Subject: **ACTIVE TRANSPORTATION PROGRAM – PROJECT SCOPE
AMENDMENT – FORT ORD REGIONAL TRAIL AND GREENWAY: CALIFORNIA
AVENUE SEGMENT PROJECT
RESOLUTION ATP-P-2425-13**

PROJECT NAME: Fort Ord Regional Trail and Greenway: California Avenue Segment

This document serves as supplemental information to the Exhibit 25-D REQUEST FOR PROJECT SCOPE CHANGE (attached) completed by Transportation Agency for Monterey County (TAMC) and submitted to Caltrans on 1-30-25.

Date: 10/17/2024
PPNO: 3130A
Federal PROJECT #: 6143(101)
ATP ID #: 0523000102

GENERAL PLAN
FORTAG California Ave Segment
Over Imjin Road

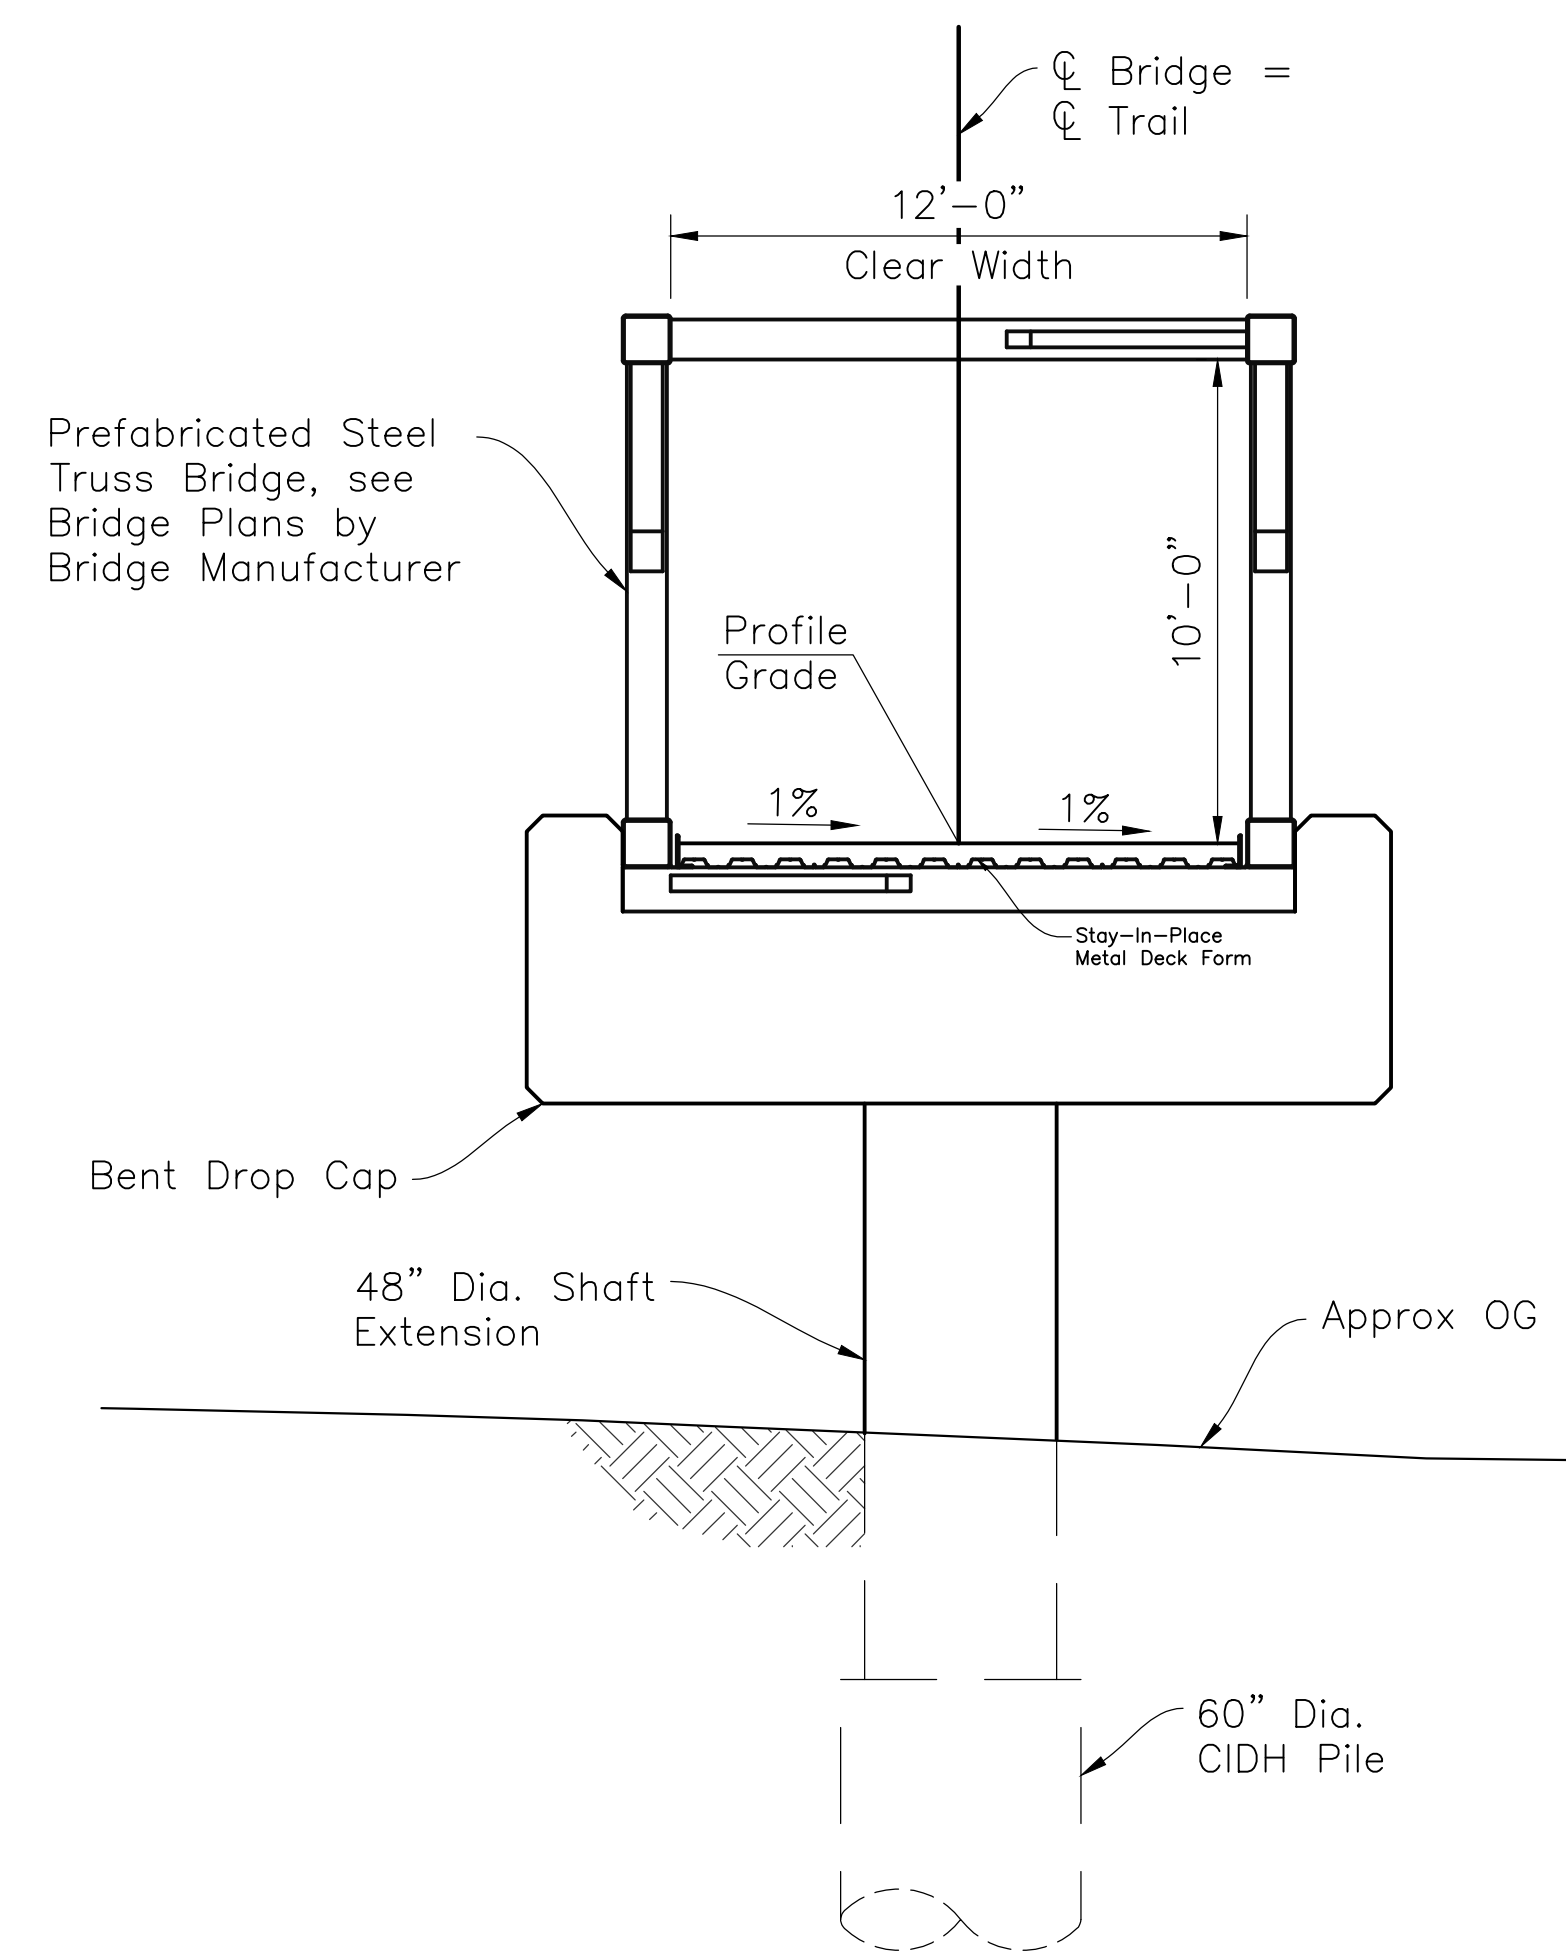
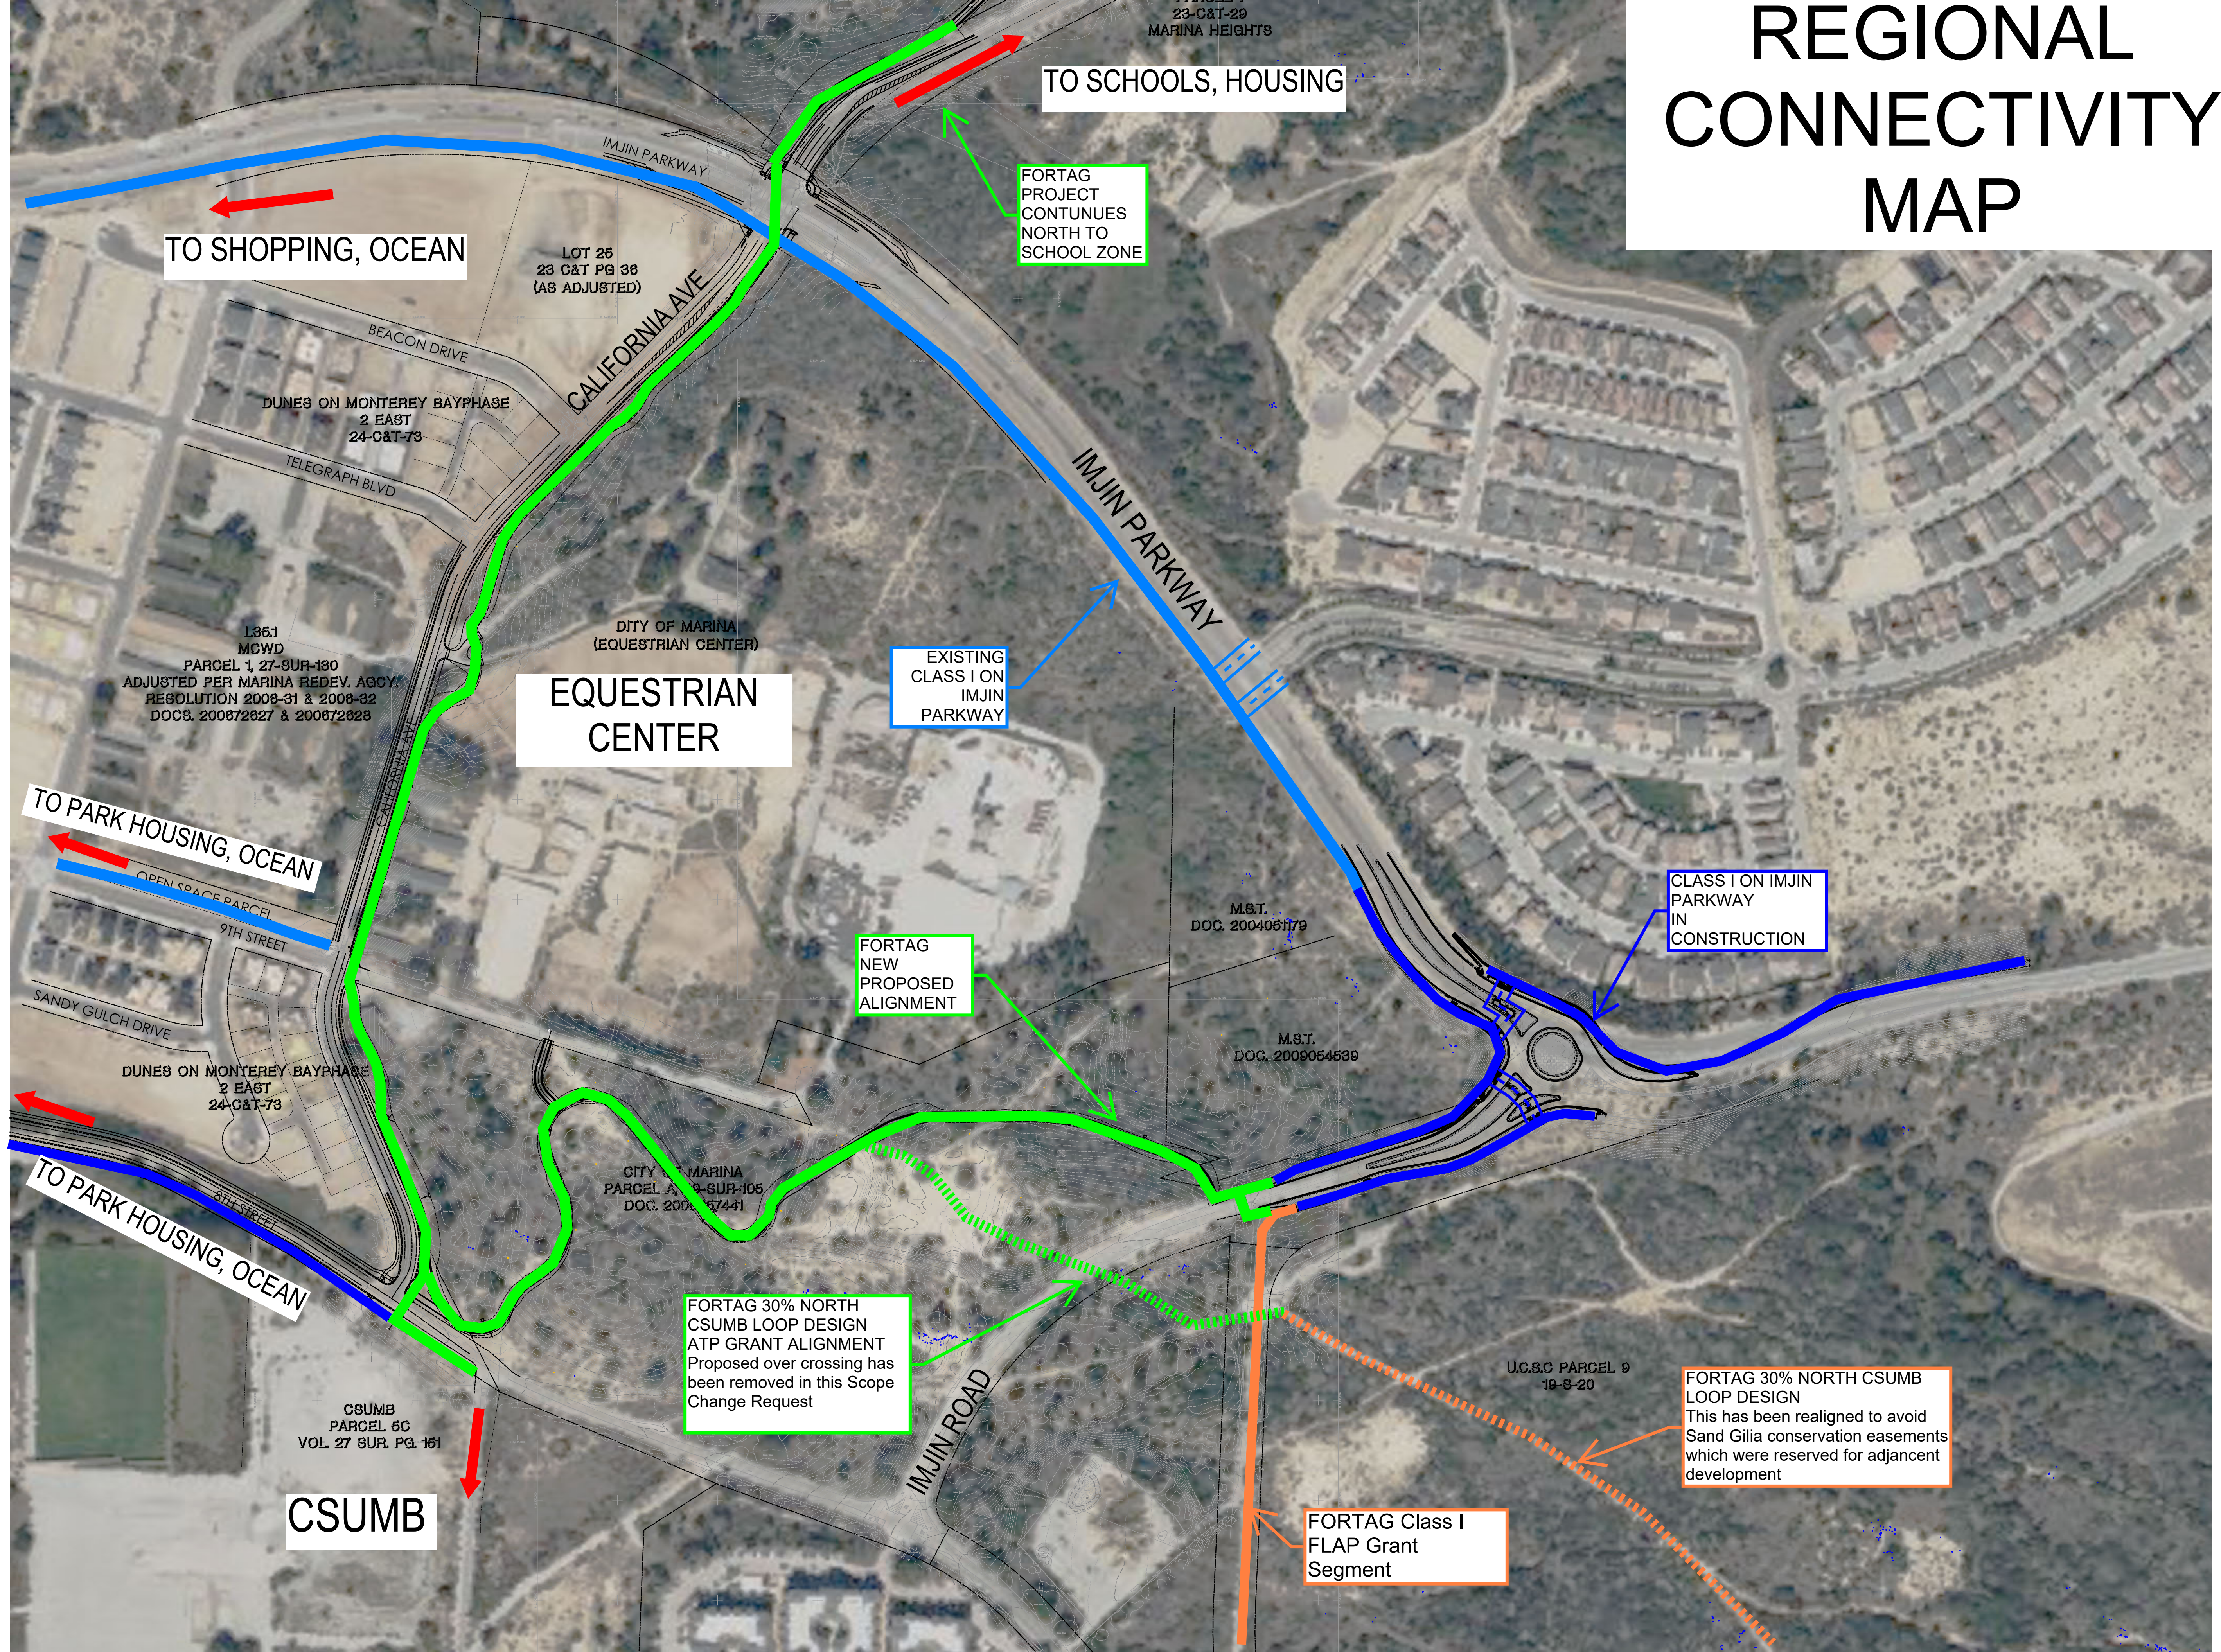
The project team explored four alternative locations for the bridge that would not infringe upon the Gilia’s critical 50-foot buffer zone and took into consideration the topography on either side of the roadway, the clearance requirements for Imjin Road, the sandy soils, and other engineering and environmental constraints. Additionally, geotechnical assessments revealed suboptimal soil conditions that would necessitate extensive and costly foundational support for the bridge abutments, further complicating the original plan.

The four alternatives included preliminary plans and cost estimates that were provided and discussed with the Transportation Agency for Monterey County (TAMC) and the City of Marina. All four alternatives would result in varying degrees of impact to the Gilia and exceeded the original cost estimate for the bridge and mitigation fees. After careful consideration, the decision was made to remove the pedestrian bridge from the project and replace it with an at-grade crossing due to high costs, poor soil conditions, challenging topography and the need to protect sensitive plant species. See Appendix D for bridge alternative plans.

Figure 1 Minimum Stopping Sight Distance

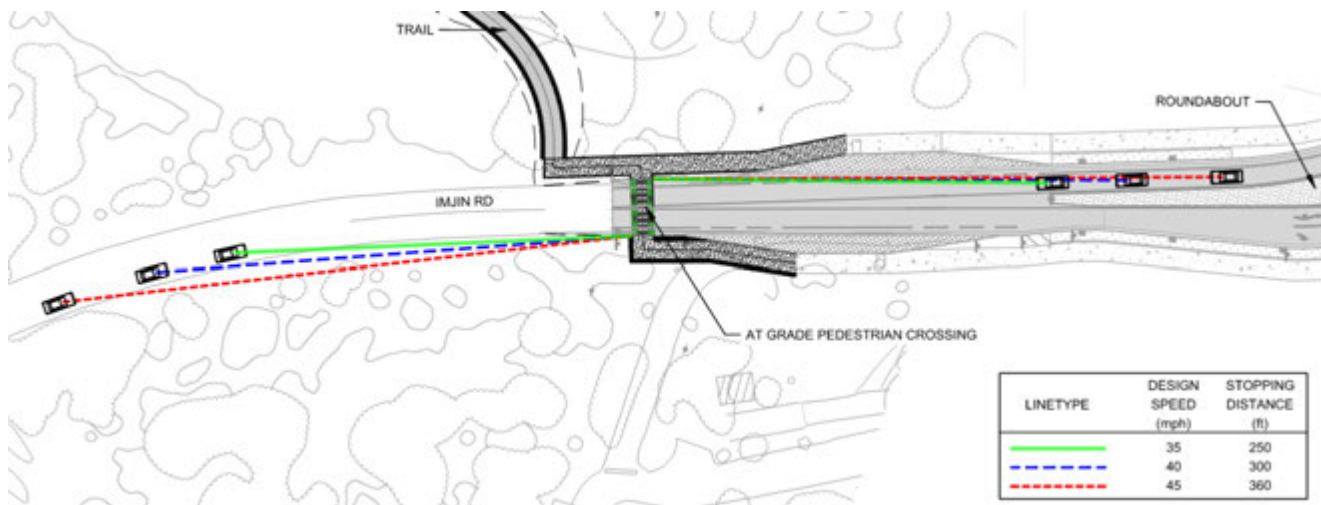
As depicted in the figure, drivers traveling westbound from Imjin Parkway at the posted 35 mph speed limit or below will have adequate sight distance to the pedestrian crossing. Drivers traveling eastbound toward Imjin Parkway have more limited sight lines approaching the proposed crossing due to roadway curvature. However, the minimum sight distance is met when traveling at or below the posted speed limit. Considering that many drivers tend to travel over the speed limit, it should be noted that the sight distance will not be adequate in these scenarios.

After reviewing the existing conditions and limitations of appropriate stopping sight distance of the proposed at-grade pedestrian crossing location, it was determined that a high visibility crossing or a rectangular rapid flashing beacon (RRFB) will not provide adequate warning protections for pedestrians and bicyclists crossing the roadway at this location. RRFBs and high visibility crossings are more effective in locations with clear sight lines to pedestrians and lower speeds. Although the posted speed limit is 35 mph and considered low enough for an RRFB, the sight lines to pedestrians waiting to cross are not adequate without the installation of curb bulbouts. Given the existing roadway width and the design of the new roundabout and bus stops to the east,

Figure 3 Pedestrian Hybrid Beacon Warrant

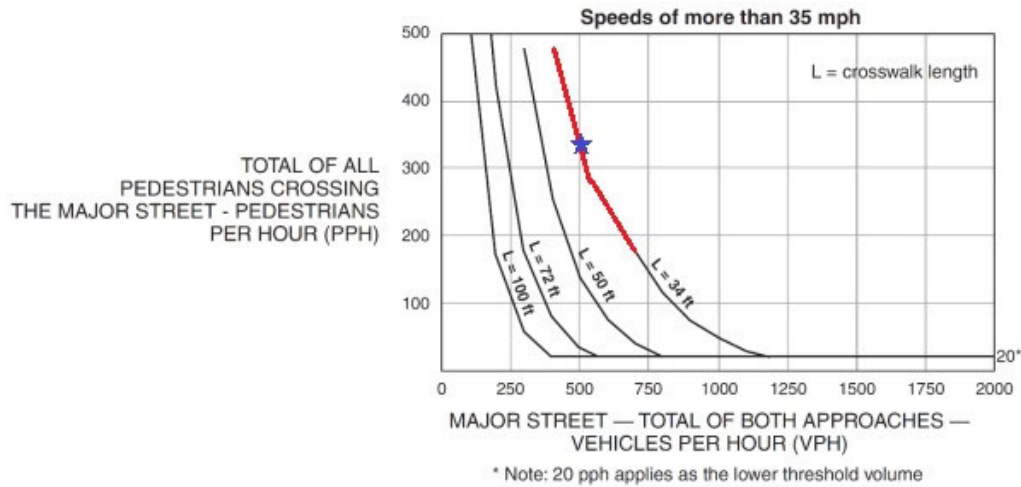
The proposed crossing is expected to be approximately 36 feet in crossing length and Imjin Road has volumes of approximately 500 total vehicles per hour. As shown in Figure 3, there would need to be approximately 250-300 pedestrians per hour to meet the warrant. While the trail is expected to draw many users, the trail may not see this many users for extended periods of time. However, it is possible the trail could see this many users at peak periods.

To provide pedestrians with a safe, visible crossing location, it is recommended that a Pedestrian Hybrid Beacon be installed at the proposed FORTAG crossing on Imjin Road. To enhance the PHB, an advanced warning flashing beacon should be considered in the eastbound direction due to the limited sight distance from the roadway curvature. Additionally, a speed table should be included as part of the crossing to change driver behavior through this area. A speed table will slow vehicles as they approach the new bus stops to the west of the proposed crossing providing increased protection for transit users at these stops as well as slow vehicles to a proper speed to navigate the new roundabout at the Imjin Road and Imjin Parkway intersection.
